Access Compliance Report

Public Rights-of-Way

(Curb Ramps)

Intersection ID: 27788	Main Street: PROVIDENCE_RD	Cross Street: PROVIDENCE_COUNTRY_CLUB_DR	Location: SW
ADA ID: 4526E0C7DA02	Ramp Type: Para	Initial Pass/Fail: Fail	Overall Compliance: No
Codes/Mitigation Info/Possible Solution		Field Measurements/Component Compliance	
Severity Score: 10

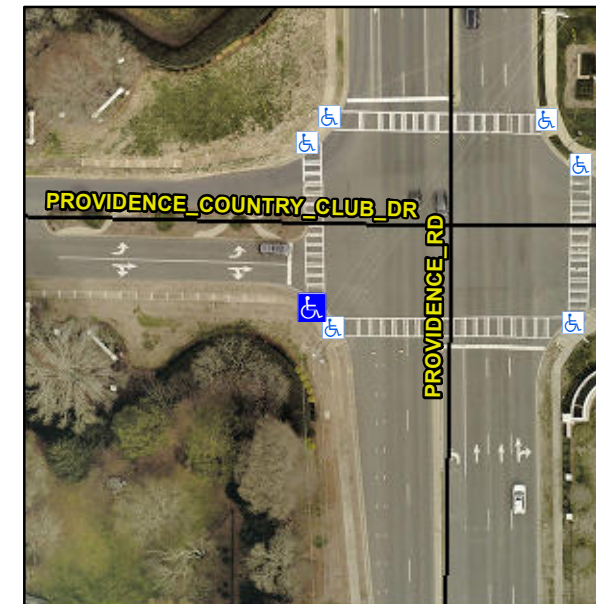
RT RP < 5%

R304.5.1, R304.5.3

Remove & Replace Entire Ramp.
